Platt Technical High School

ADDENDUM NO. 4

August 9, 2019

9 EXTERIOR PLAN DETAIL
1 1/2" = 1'-0"

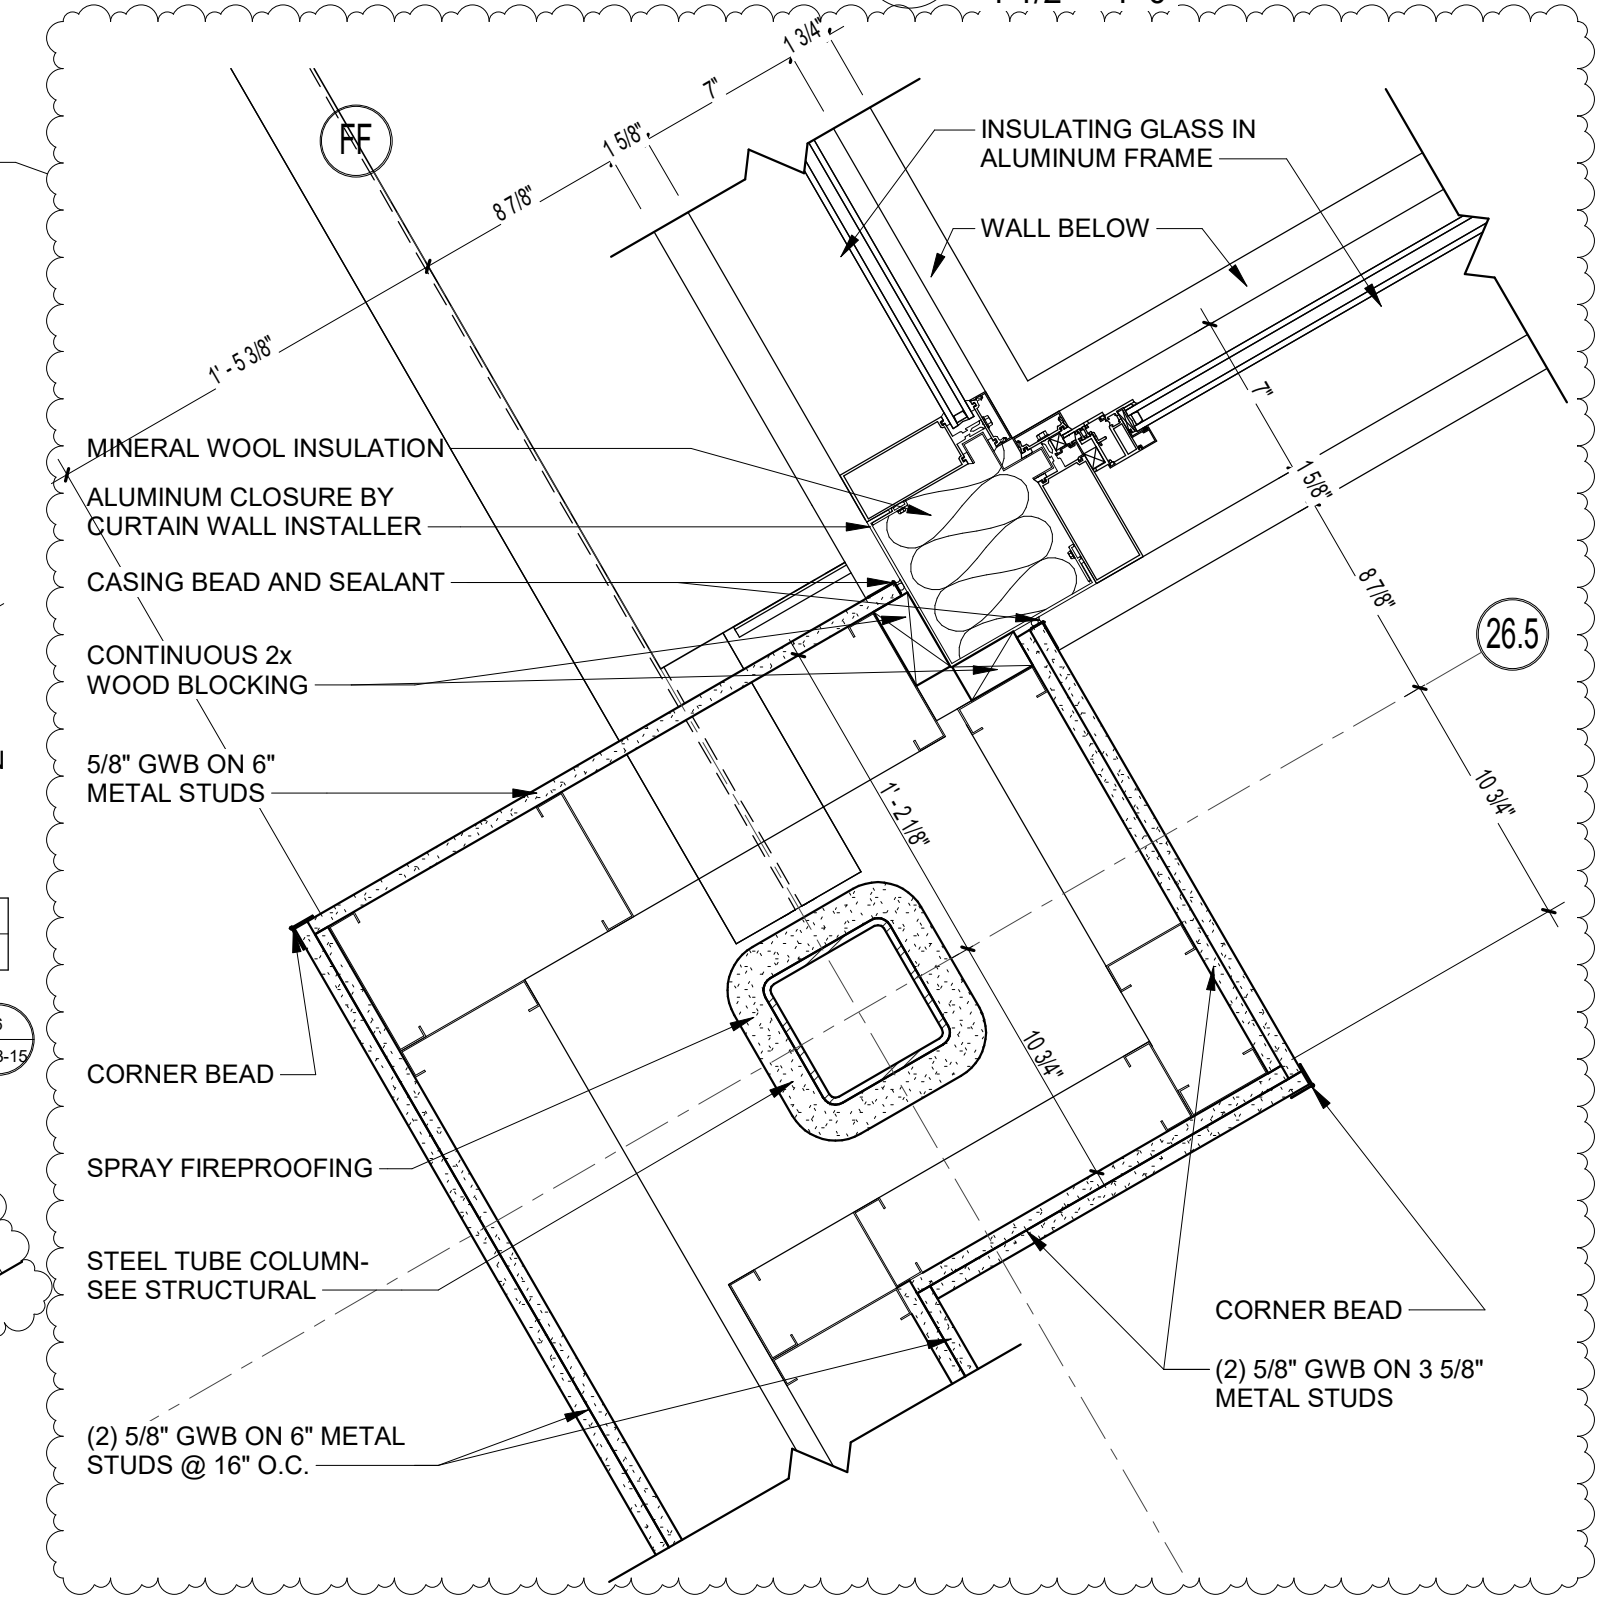
- ADD 4-094 A5-1-1 – EXTERIOR PLAN DETAILS**
Plan Detail 11: REVISED Aluminum Frame jamb detailing per Revision Sketch RA4-14.
- ADD 4-095 A5-1-4 – EXTERIOR PLAN DETAILS**
Details 4, 6, 9, & 10: Revised detailing per revision Tag RA4-15.

100% CONSTRUCTION DOCUMENTS
 drawing title: DOOR SCHEDULE

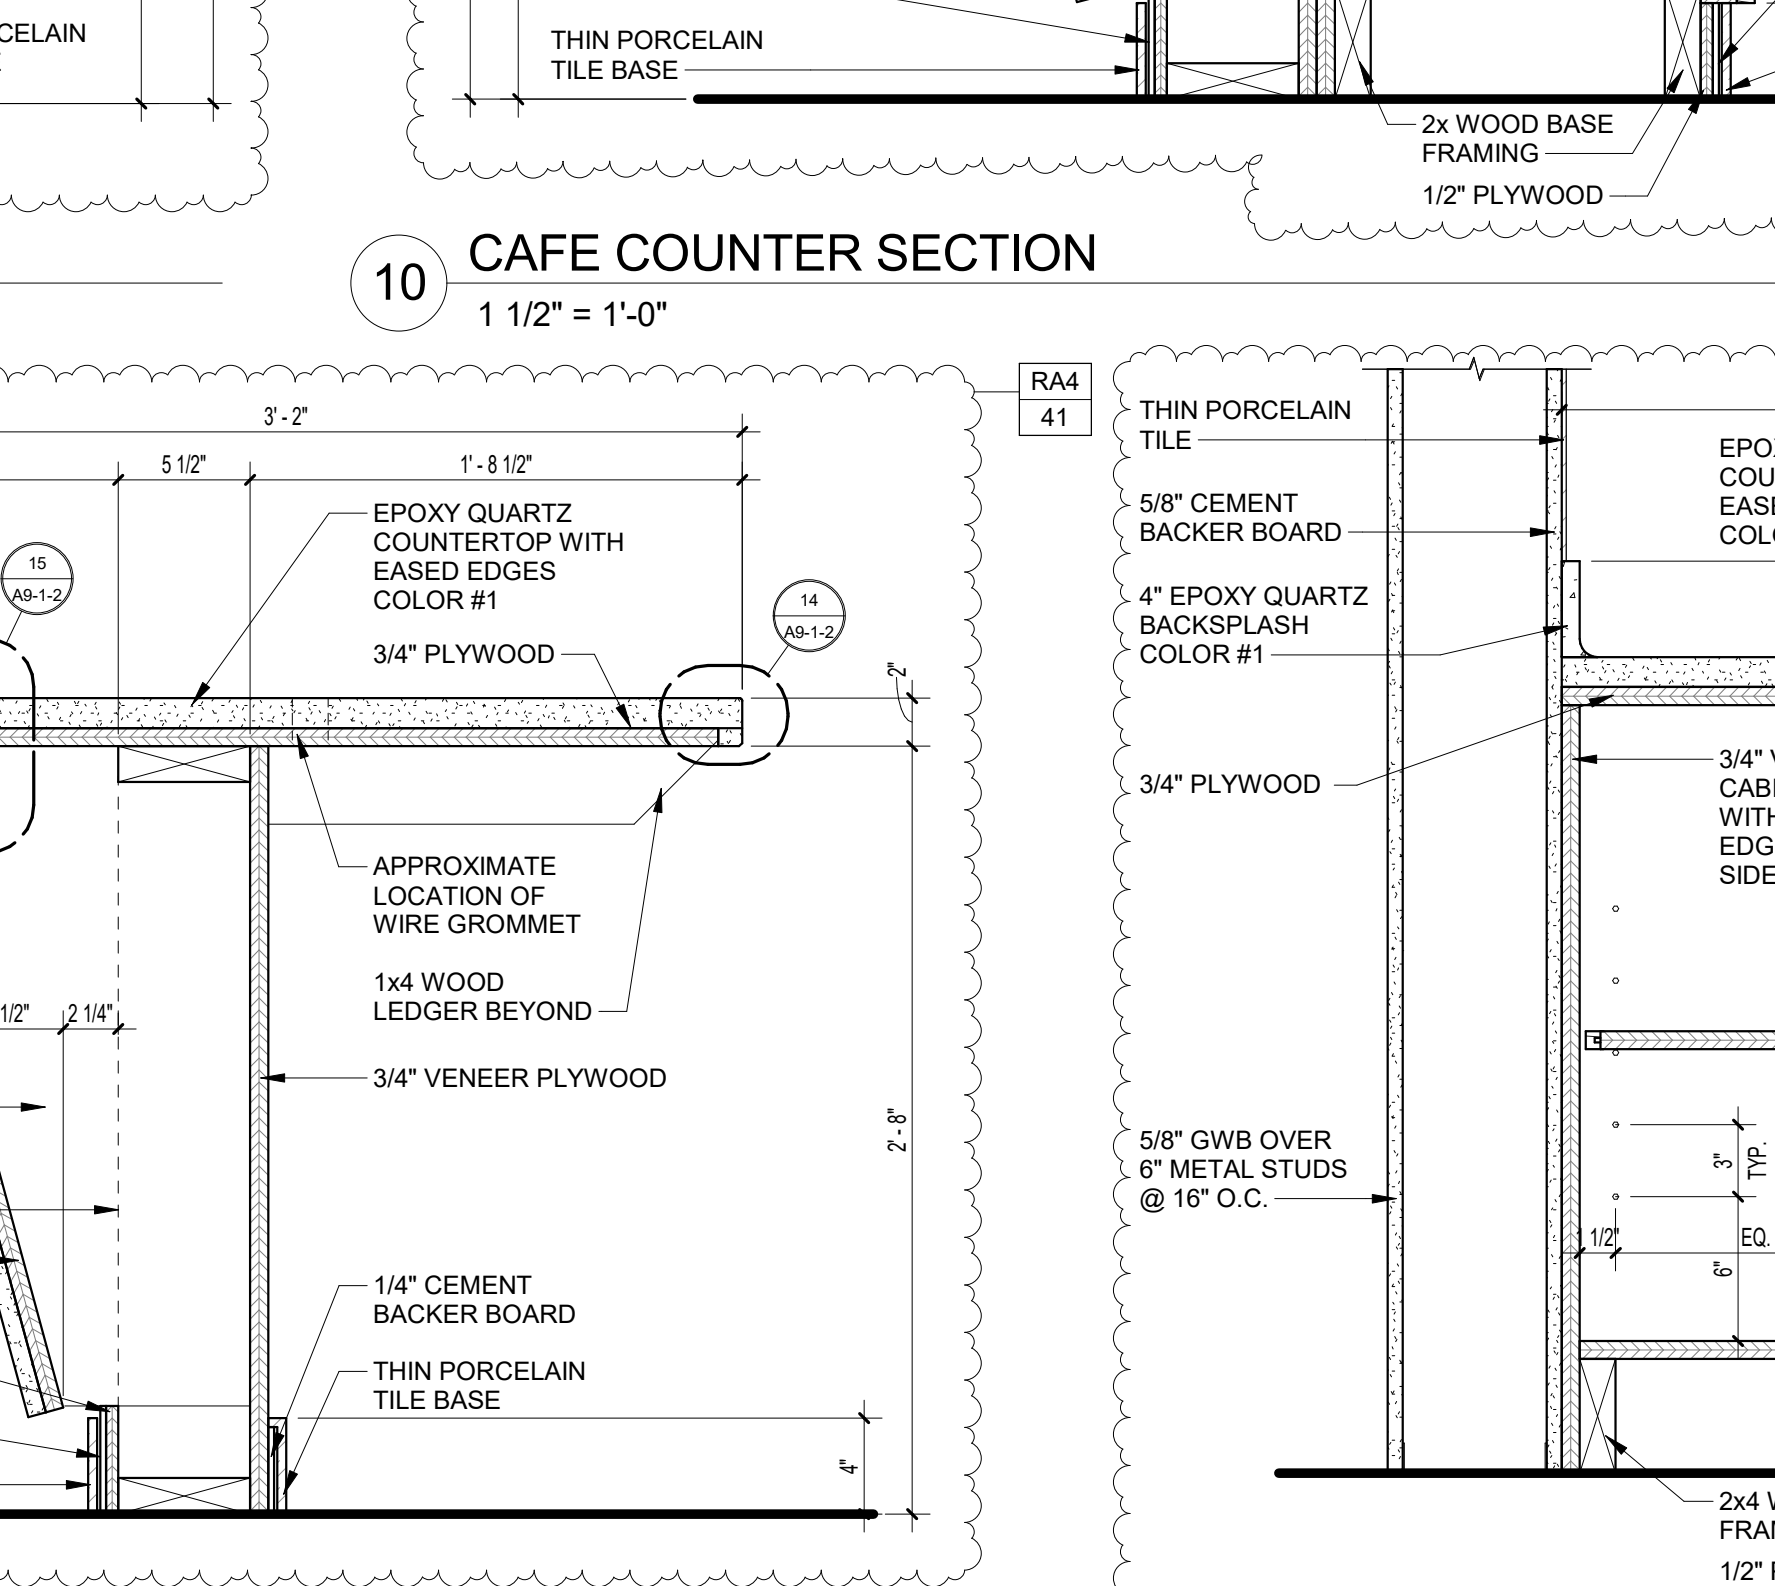
- ADD 4-099** **A6-2-1 – DOOR SCHEDULE**
Door B159.1: Revised Frame Type per revision Tag RA4-16.
Door B162.1: Revised Frame Type per revision Tag RA4-16.
Cleaned up graphics per revision Tag RA4-16.

- ADD 4-100** **A6-2-1 – DOOR SCHEDULE**
Door B127.1: Change Door Type to “FW2.” Change Door Material to “MTL (Metal)”
Door B127.2: Change Door Type to “FW2.”
Door B140.1: Change Door Type to “FW2.”
